FEDERAL FACILITY AGREEMENT AND CONSENT ORDER (FFACO)

RECORD OF TECHNICAL CHANGE (ROTC)

Corrective Action Unit (CAU) Number: 550

CAU Description: Smoky Contamination Area

Figure 1-1
CAU 550 CAS and Releases

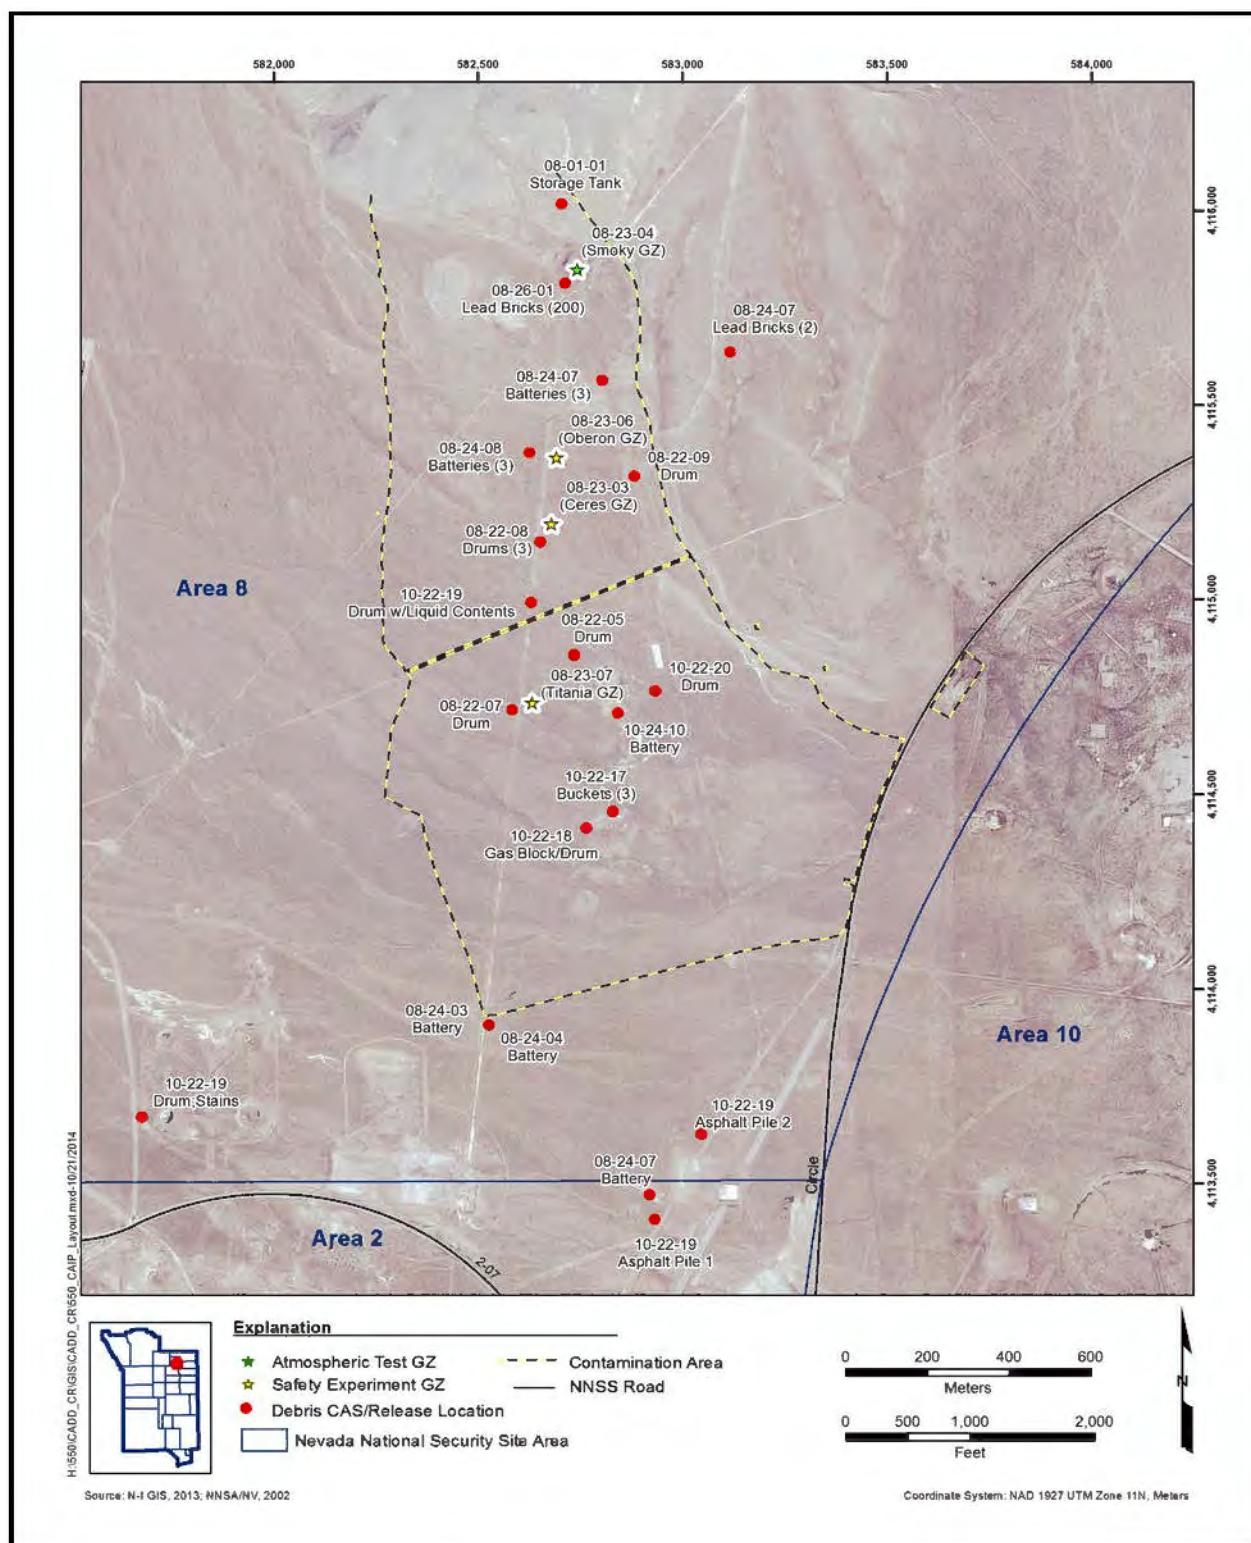
2.) Figure 1-1, Page 2		Identify the drainage system and catchment basins as described in ES. Global comment for other figures as appropriate.	<p>The primary purpose of Figure 1-1 is to present the CASs included in CAU 550. The drainage system and catchment area are not part of a CAS, but were investigated as a study group (SG3). Although the four CAU 550 study groups are briefly introduced in Section 1.0 (Table 1-1), they are not discussed in detail until Section 2.0. Specifically, Section 2.1.3 addresses Study Group 3 (Washes). This section references Figure A.5-1, which presents the drainage system and catchment area features (U10a crater, depositional area, sediment accumulation areas). No changes were made to Figure 1-1; however, Figure A.5-1 was revised to identify the catchment area on the east side of Circle Road.</p>

Figure A.4-1
Study Group 2 DCB

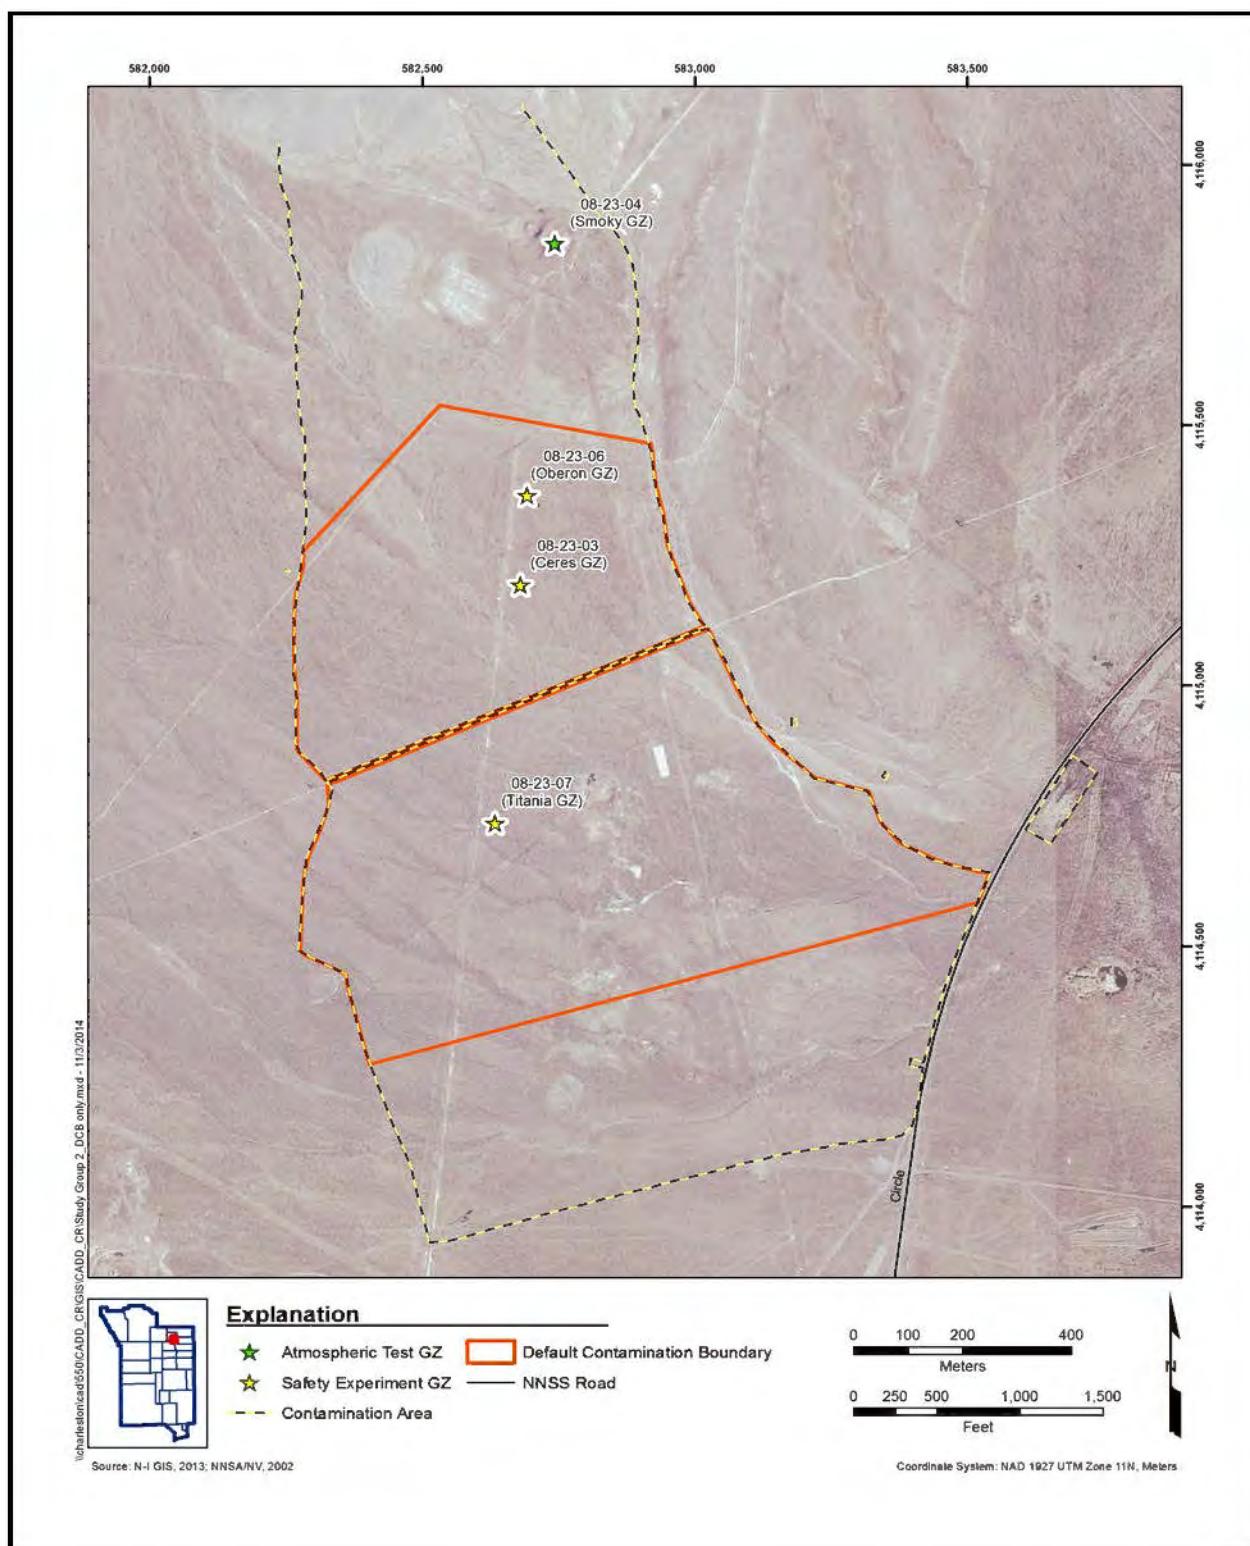
10. Comment Number/Location	11. Type*	12. Comment	13. Comment Response		14. Accept
5.) Section 2.1.2, Page 13, 1st Paragraph		The section seems to imply the DCBs shown in Figure A.4-1 and elsewhere are also HCA boundaries. If so, should appropriate figures be labeled as such, and are these currently field posted as HCAs? Clarify.	<p>At CAU 550, the DCB is not collocated with a posted HCA. The east and west boundaries of the DCB follow an existing fence line that is currently posted as a CA. The DCB was established during the CAI because HCA conditions were identified in the area. However, the responsibility for identifying, posting, and maintaining an HCA (or CA) rests with the DOE Occupational Radiation Protection program (governed by 10 CFR 835), which is independent of the FFACO process. Section 2.1.2 has been revised to clarify the applicability of relevant components of the DOE Occupational Radiation Protection program to the FFACO process.</p> <p>Section 2.1.2, second paragraph has been replaced with the following: "A default contamination boundary (DCB) surrounding the three safety experiments was established based on historical removable contamination survey data, which suggested the presence of high contamination area (HCA) conditions within the DCB (NNSA/NSO, 2012). The east and west boundaries of the DCB follow an existing fence line that is currently posted as a CA (see Figure A.4-1). However, the DCB does not coincide with a posted HCA. The responsibility for identifying, posting, and maintaining an HCA (or CA) rests with the DOE Occupational Radiation Protection program, which is governed by the requirements in 10 CFR 835, "Occupational Radiation Protection"(CFR, 2013). This program was established for worker health and safety, and is independent of the FFACO. However, the data collected in support of the program and the existing postings are relevant in determining the radiological conditions at a site."</p>

9.) Section A.4.1, Page A-38, 2nd Paragraph		1st sentence: "within the boundary" - clarify if these means the DCB boundary is also an HCA boundary.	See response to comment #5. The sentence has been revised to read, "A DCB surrounding the three safety experiments was proposed in the CAIP (NNSA/NSO, 2012a) based on historical removable contamination survey data, which suggested the presence of HCA conditions within the DCB (Figure A.4-1)."

Figure A.4-3
Study Group 2 Estimated Northern Extent of CA Conditions

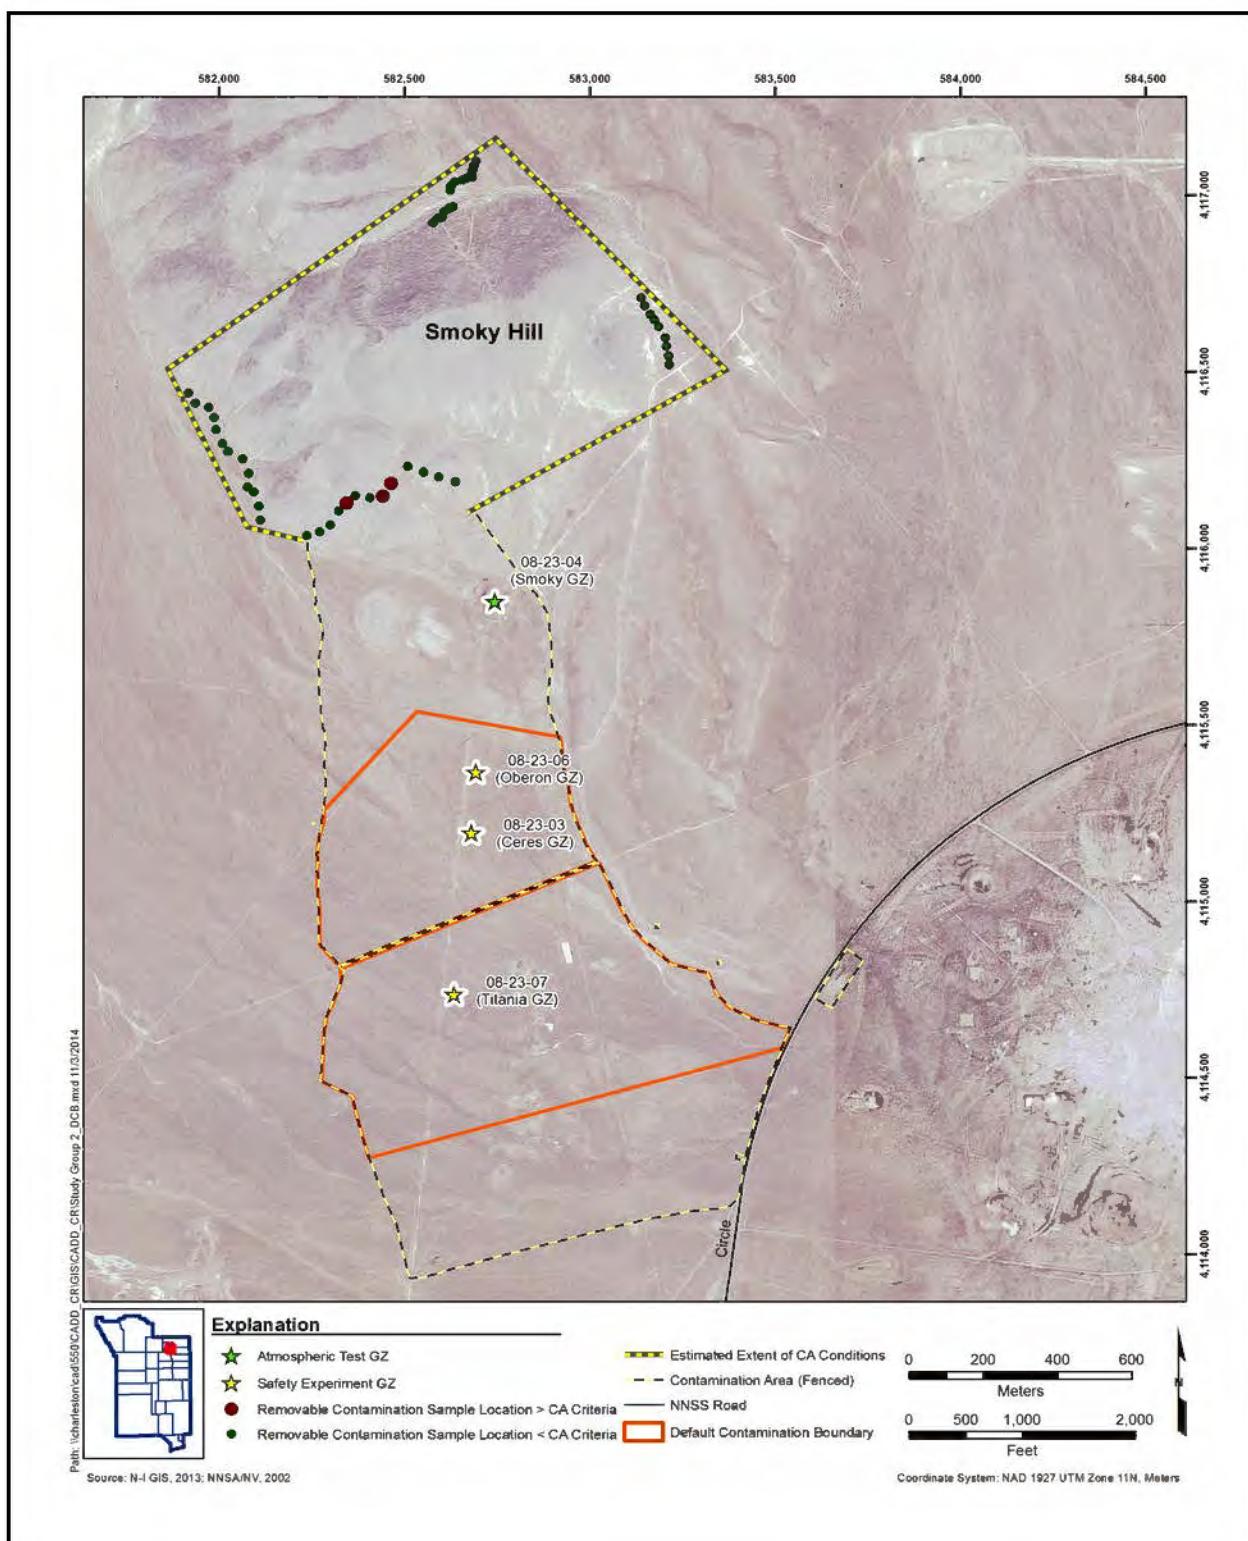
11.) Section A.4.5, Page A-45, 1st Paragraph		<p>4th sentence: Figure A.4-3 appears to show 3 removable contamination sample locations exceeding CA criteria, contradicting this sentence.</p> <p>4th sentence: change the phrase "confirming that CA conditions" to "suggesting that CA conditions..."</p> <p>Last sentence: convoluted, replace with "Due to the long half-lives of removable radioactive contaminants, including Pu-239 (24,000 years), the administrative UR is expected to remain in place indefinitely".</p>	<p>This discussion has been revised to read, "The fence line, however, is discontinuous across the northern portion of the site (Figure A.4-1), and it was uncertain as to the extent of CA conditions in this area of the CAU. According to a 2000 radiological survey report, the northern portion of the CA was not fenced due to the extremely steep terrain north of the site (DOE/NV, 2000a). In order to determine the northern extent of the area with CA conditions, removable contamination swipes were collected around the base of Smoky Hill. As shown in Figure A.4-3, three of the southernmost swipe locations exceed CA criteria. None of the other swipe locations around the base of the hill meet CA criteria. This suggests that CA conditions are present at the southern base of Smoky Hill and potentially extend to higher elevations on the southern side of the hill, but do not extend beyond the base of the hill in the west, north, and east directions."</p> <p>Last sentence was revised as requested.</p>

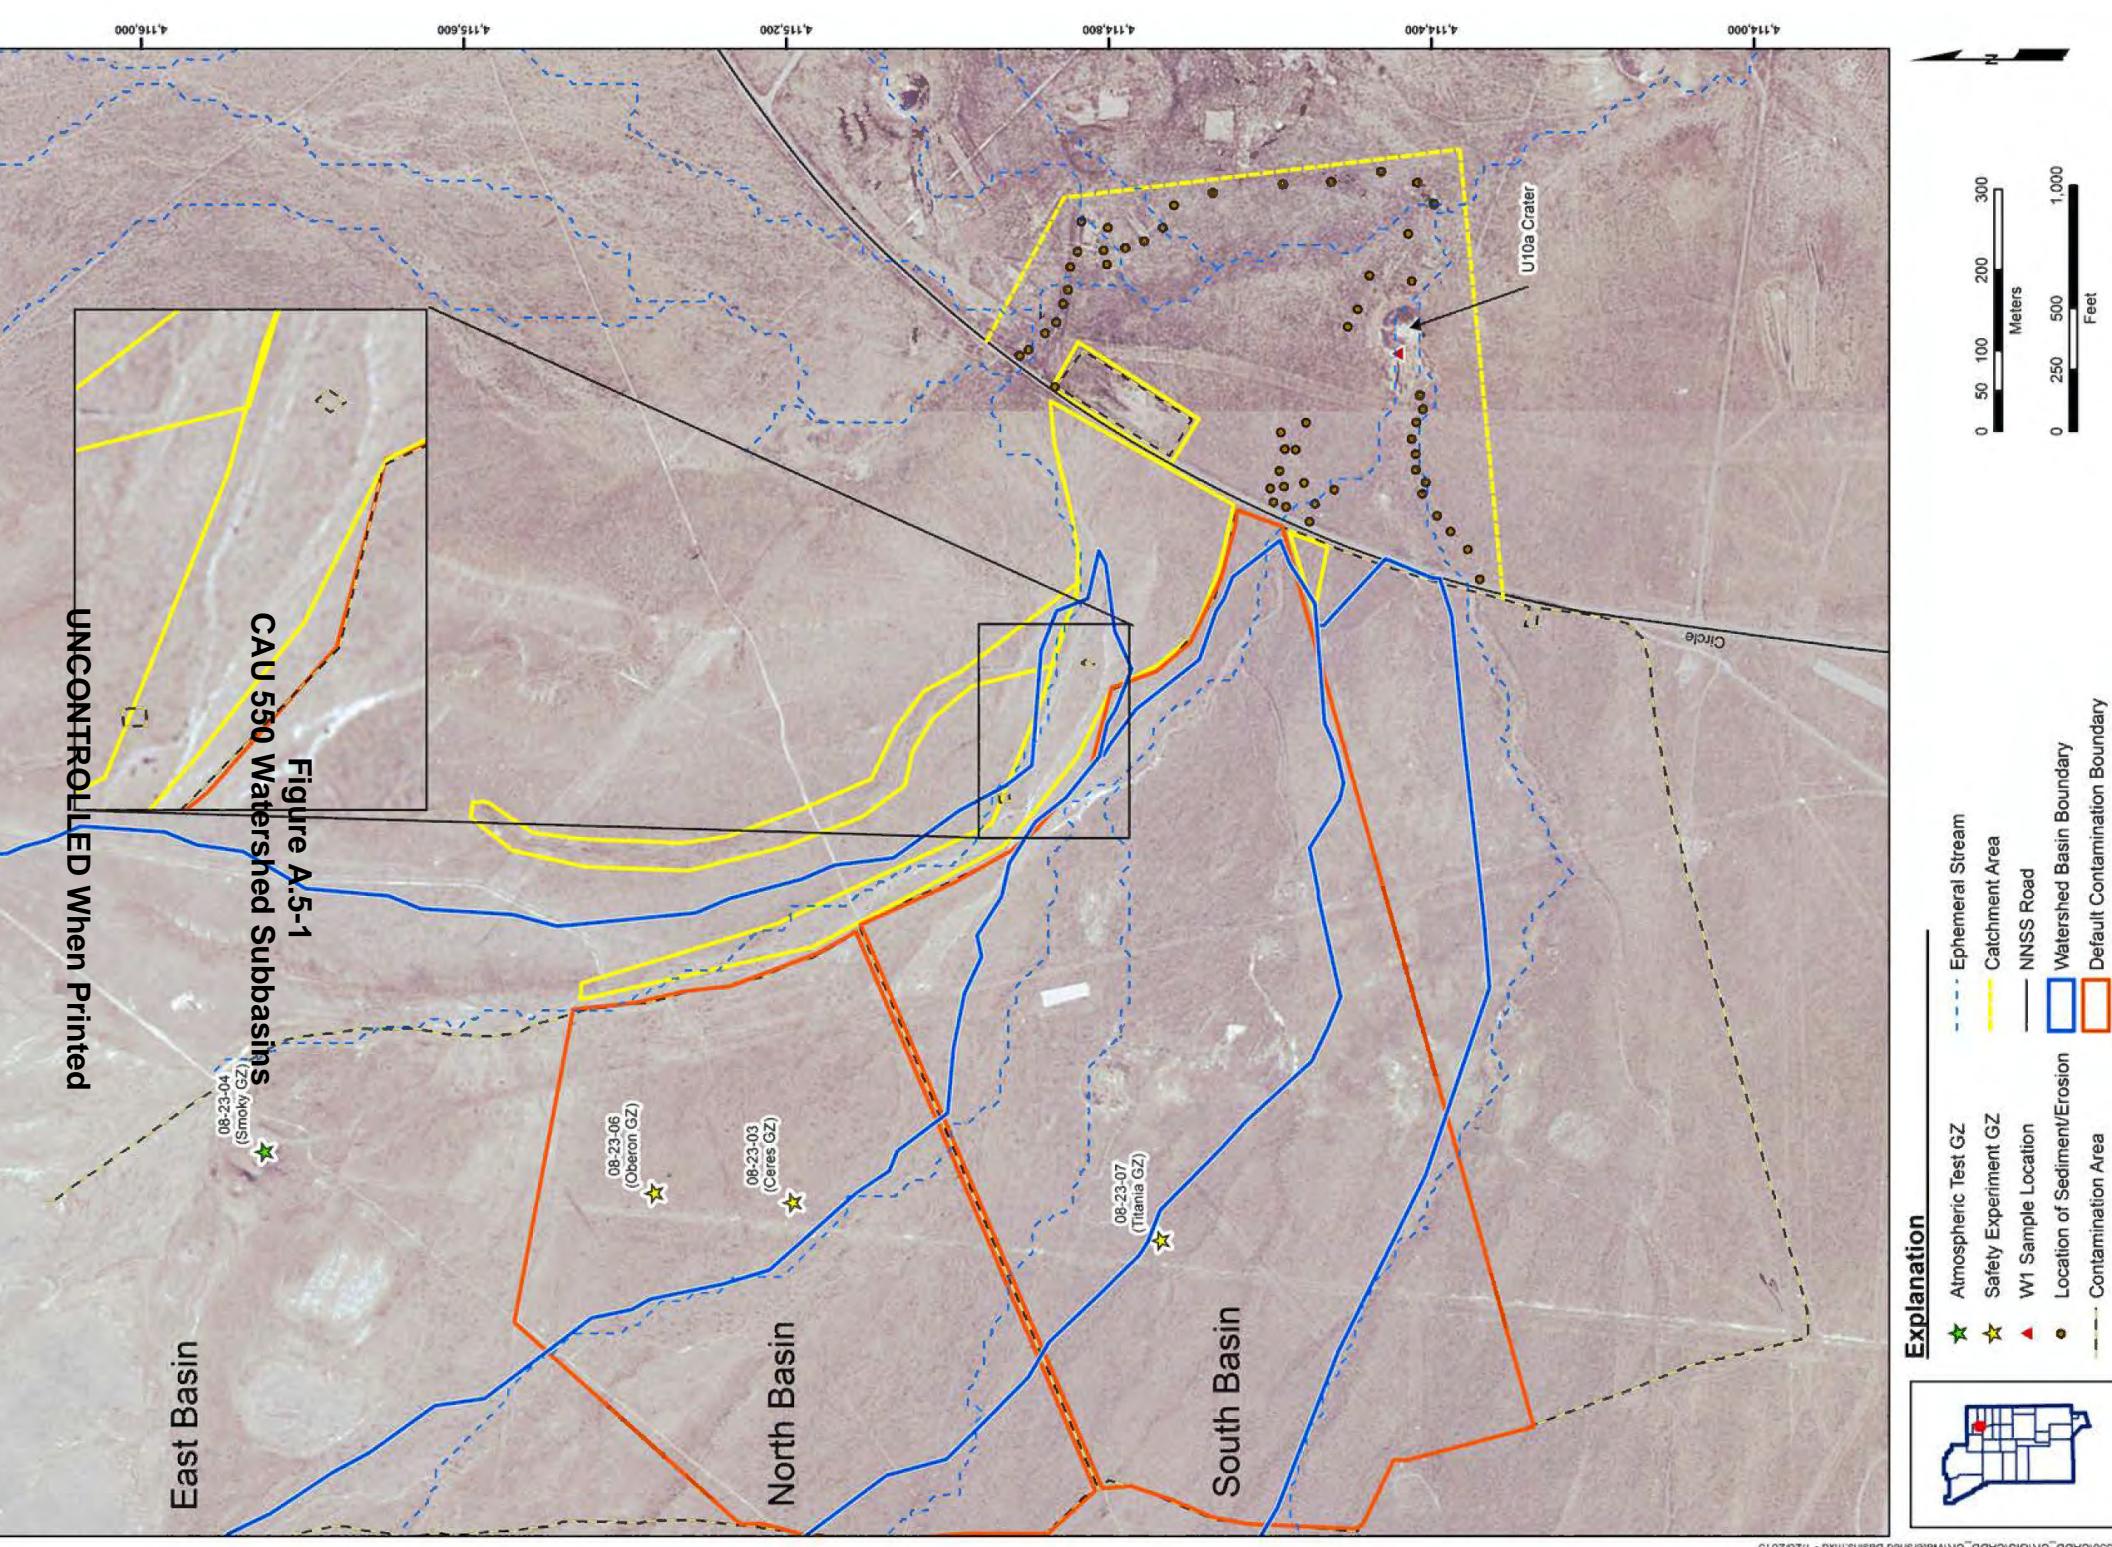
10. Comment Number/Location	11. Type*	12. Comment	13. Comment Response		14. Accept
12.) Section A.5.1.1, Pages A-47-49, 1st-3rd Paragraphs		<p>3rd sentence: "...two small posted areas..." are difficult to discern in Figure A.5-1.</p> <p>Figure A.5-1: add basin boundary symbols to legend.</p> <p>Figure A.5-1: identify U10a crater.</p>	<p>An inset that is zoomed into the two posted areas has been placed on Figure A.5-1.</p> <p>Figure A.5-1 was revised to add the basin boundary symbol to the legend and identify the U10a crater.</p>

14.) Section A.5.5, Page A-59, 1st Paragraph		1st sentence: call out Figure where locations of sediment accumulation are shown.	The sentence was revised to read, "The extent of the administrative UR on the east side of Circle Road was determined visually and was based on the locations of sediment accumulation (Figure A.5-1)."
